**CASE COVER SHEET**

City of Rockwall  
Planning and Zoning Department  
385 S. Goliad Street  
Rockwall, Texas 75087

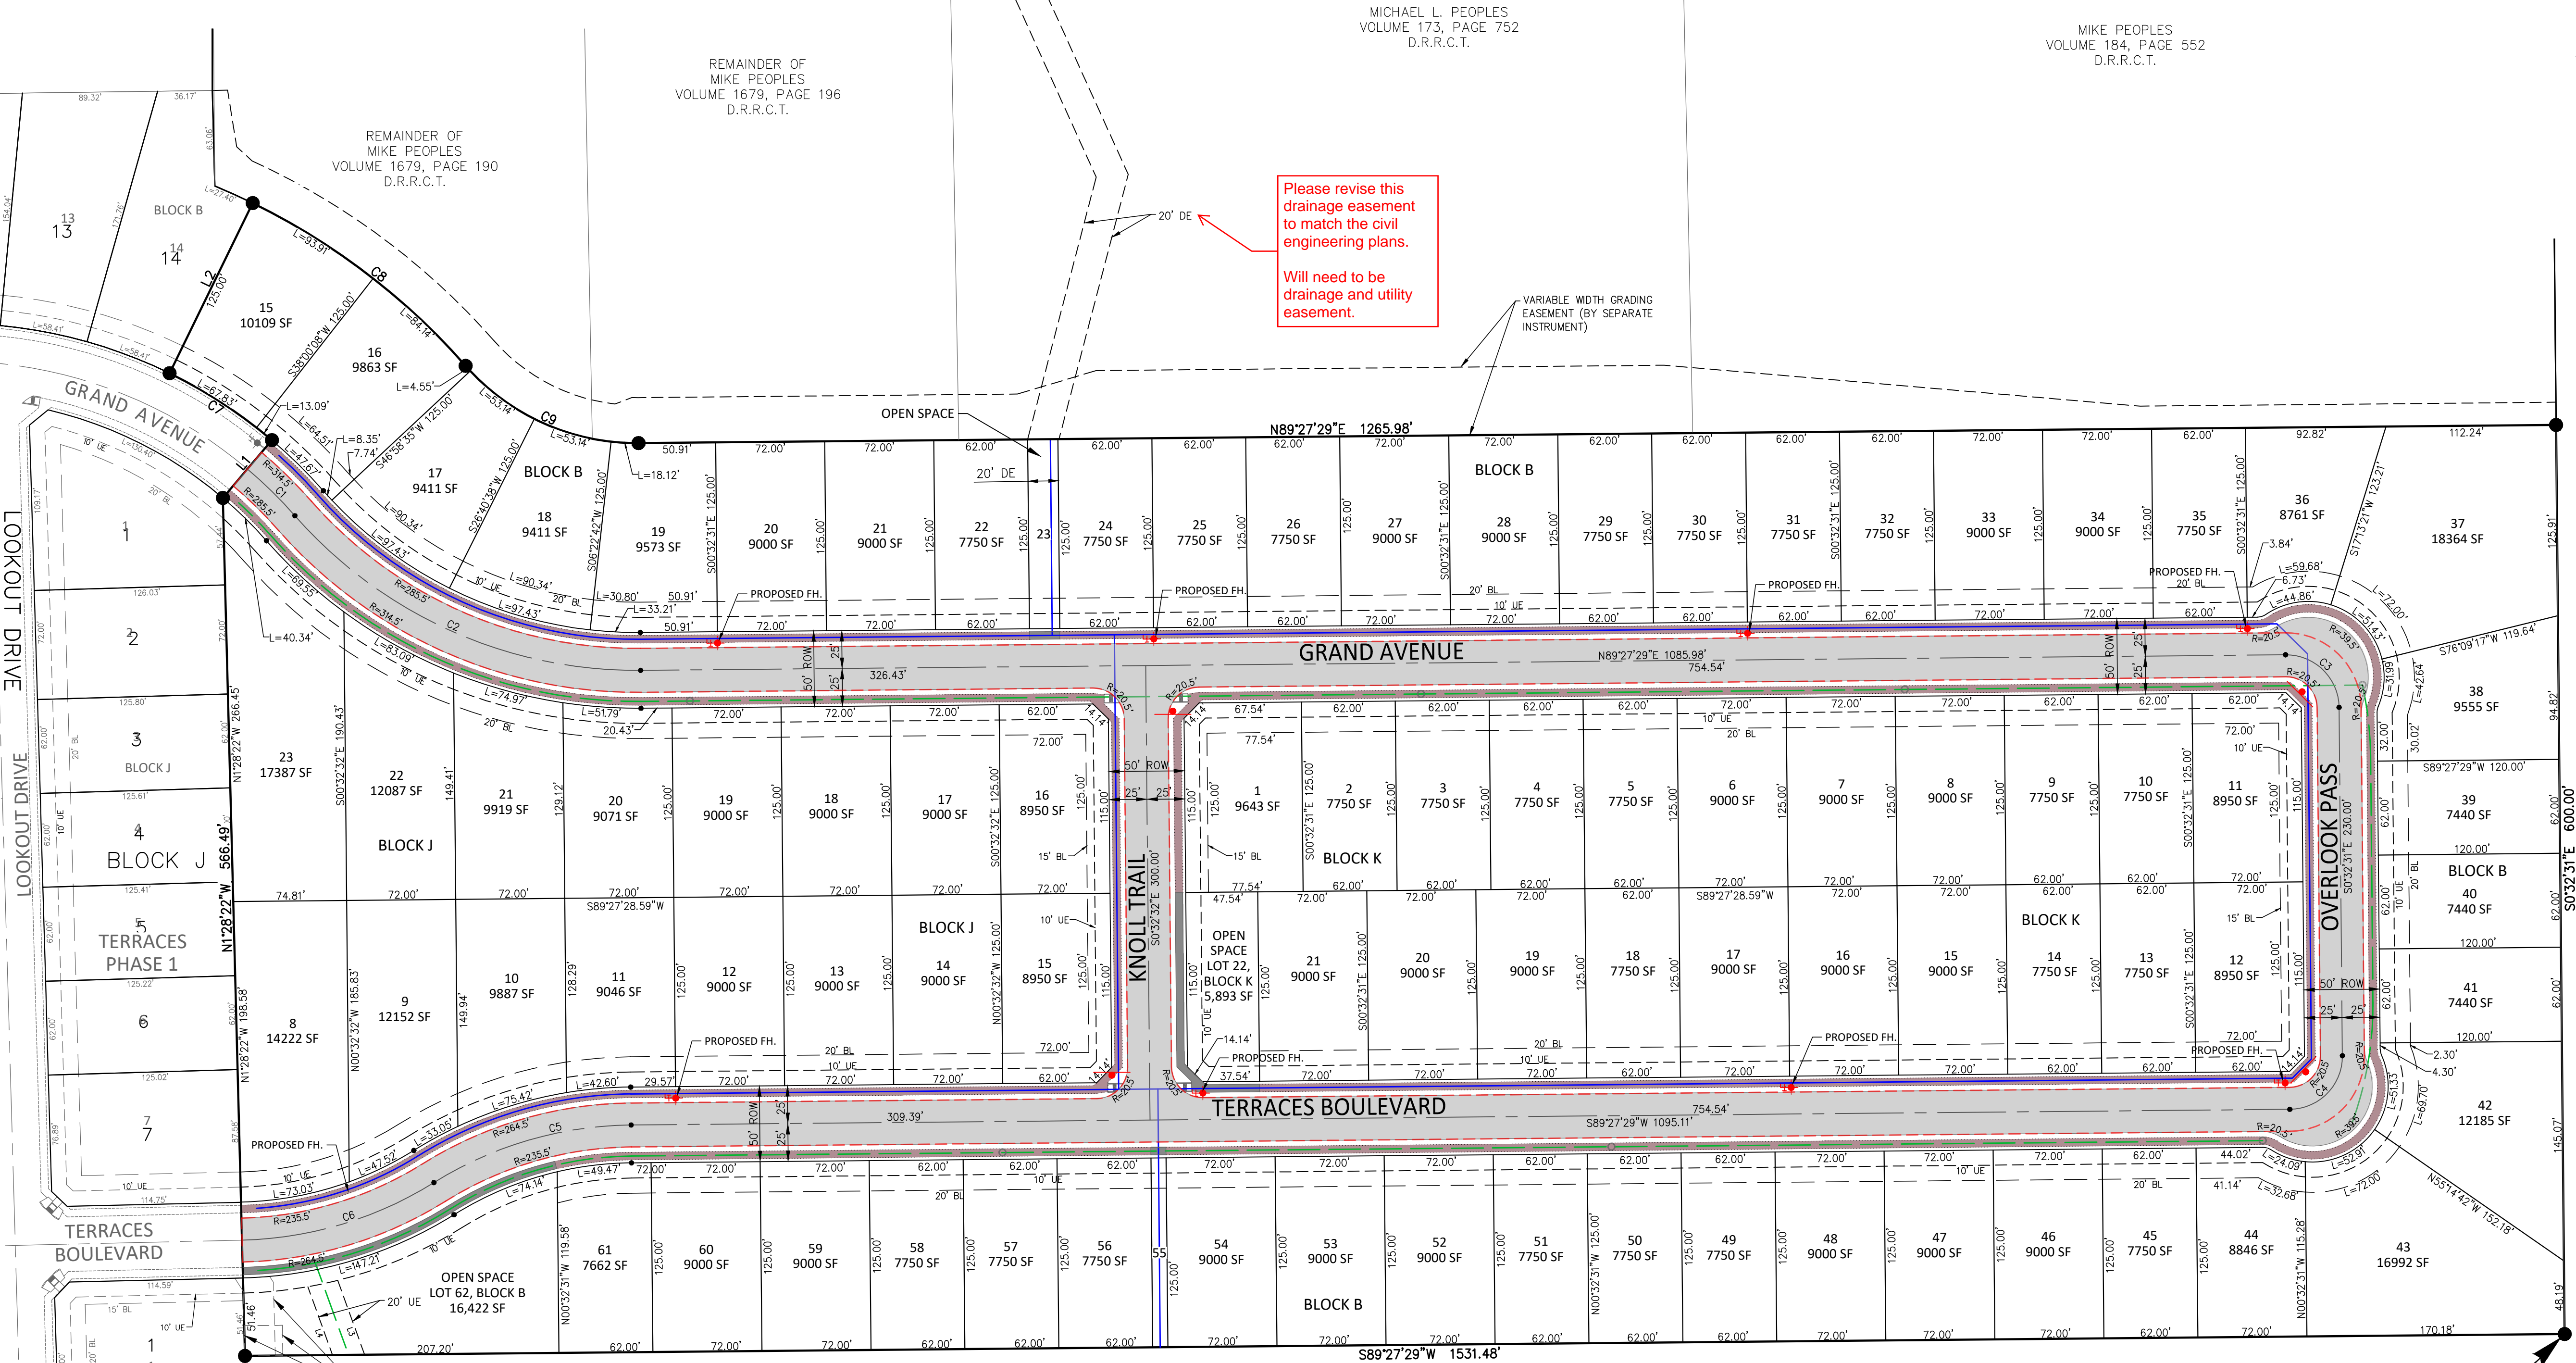
Utility layout subject to change with engineering plan review.
